APPEAL SUMMARY

Appeal ID: 22237	Project Address: 1627 SE Reedway St
Hearing Date: 12/18/19	Appellant Name: Steve Fosler
Case No.: B-007	Appellant Phone: 503 2419339
Appeal Type: Building	Plans Examiner/Inspector: Kathy Aulwes
Project Type: commercial	Stories: 2 Occupancy: R-2 Construction Type: V-A
Building/Business Name: SE Reedway	Fire Sprinklers: Yes - throughout
Appeal Involves: Erection of a new structure	LUR or Permit Application No.: 17-284260-REV-01-CO
Plan Submitted Option: pdf [File 1]	Proposed use: apartments

Project
1631 SE. REEDWAY STREET
Redway Street Apartments
Portland, OR 97202

Sheet
A101.0

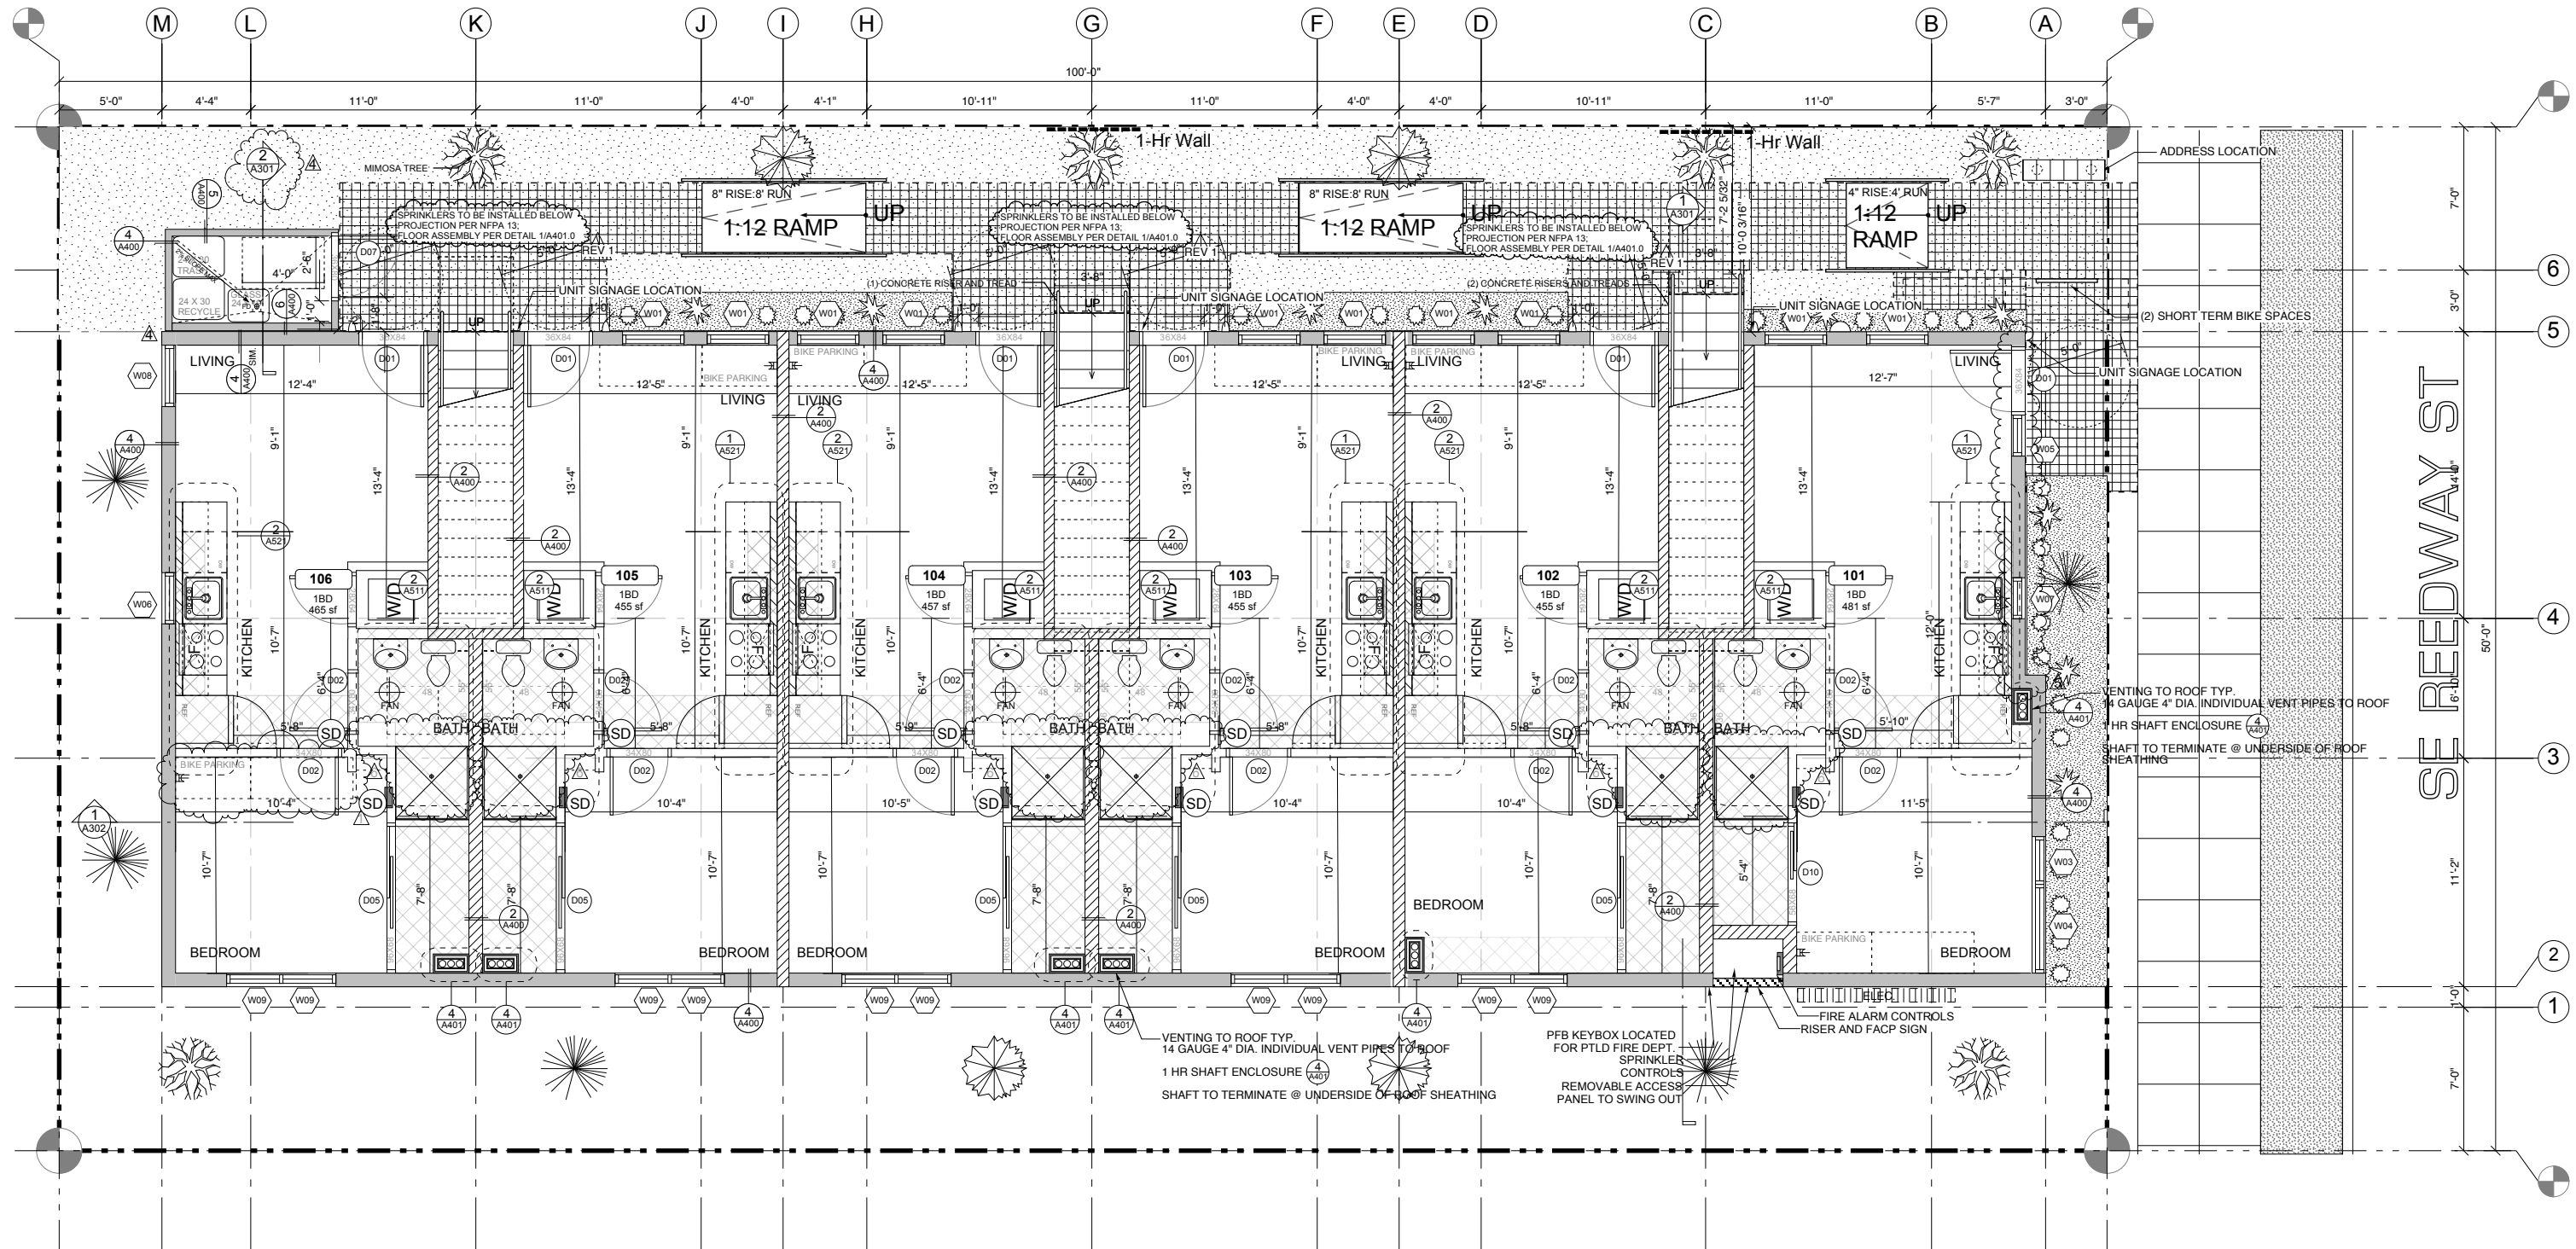
Code Section	1026.5
Requires	<p>1026.5 Exterior exit stairways shall have a minimum fire separation distance of 10' measured from the exterior edge of the stairway to adjacent lot lines...</p> <p>DESCRIPTION OF APPEAL;</p> <p>To allow two egress stairs to extend into the 10' fire separation distance by 11" and 22"</p>
Proposed Design	<p>Three exit stairways, each serving two 2nd floor apartments, egress to the 10' courtyard. Due to the slope in the site, two stairways have risers and treads that extent into the 10' fire separation distance.</p> <p>One stairway extends one tread (11") into the fire separation distance.</p> <p>A second stairway extends two treads (22") into the separation distance.</p> <p>The third stairway does not extend into the separation distance.</p> <p>The portions of the two stairs that extend into the 10' separation distance will be constructed of non-combustible material and a 6' high by 4' long heavy timber one-hour assembly (wall panel constructed of nom 4" thick PT wood) will be constructed in the fence line on the property line at two locations opposite each of these two stairways. (see site plan)</p>

Reason for alternative	The segments of rated walls at the property lines opposite the stairways provide the equivalent or better protection of the 9'-1" and 8'-2" distance from the property lines than the open 10' fire separation required by code.

Requires	<p>1027.4.2 Egress Court Construction and Openings</p> <p>Where an egress court...is less than 10' in width, the egress court walls shall have not less than 1-hour fire-resistive rated construction for a distant of 10' above the floor of the court.</p> <p>Openings...shall be protected by opening protectives... of not less than 3/4 hour.</p> <p>DESCRIPTION OF APPEAL:</p> <p>To allow non-rated openings in the non-rated wall of the egress court.</p>
Proposed Design	<p>The wall of the building is 10' from the property line and the effective width of the egress court is 10' except for the two locations where a bottom tread and riser extend into the 10' width (per Item #1 of this appeal).</p> <p>The building is to be fully sprinklered.</p> <p>These two minor stair extensions do not reduce the life safety characteristics of the court, they do not diminish egress capabilities nor is the overall effective width of the egress court reduced.</p> <p>So the wall of the building should not required = be one-hour rated and the openings should not required to be 3/4 hour rated.</p>

Reason for alternative	<p>The stairways were modified due to unexpected grade issues during construction which required additional risers and treads.</p> <p>The egress court width is technically less than 10' wide at those two 4' wide locations but the remaining 85' of the egress court is the full 10' clear as required by this code section.</p> <p>The egress pathway is clearly delineated by pavers and planters, and these two stair encroachments do not encroach on the required egress width nor do they reduce the width of direct path of travel to the right of way.</p>

1. Location of exterior exit stair within 10 feet of property line: Granted provided a 7 foot high 1 hour fire rated wall is provided adjacent to the property line extending a minimum of 1 foot beyond each side of the stairs and provided the 1 hour rating of the wall is confirmed at time of plan review.

2. Exterior wall openings in egress court less than 10 feet in width: Granted as proposed.
Appellant may contact John Butler (503 823-7339) with questions.
